P5005A-02

# Information Only Service Note

# P5005A Keysight Streamline USB Vector Network Analyzer

False alarm on self-test failure on firmware revision of A.13.40.02 - DDR3 memory removal

#### Self-test

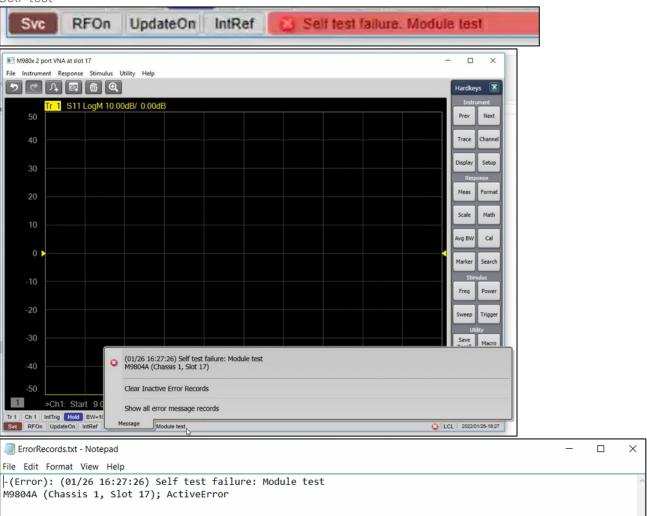
The on board DDR 3 memory in VNA is not in use since its release. With the removal of DDR 3 memory IC on newer P500xA VNA, right after firmware is launched, false alarm (self-test failure) will be reported as shown. This has no impact to VNA performance and specifications.

Similarly, firmware will report a false failure in Operator check. Shown are the error messages example on VNA firmware UI.

For users with firmware revision of A.13.40.02, Update firmware to revision A.13.70.02 or newer to resolve this false alarm on self-test.
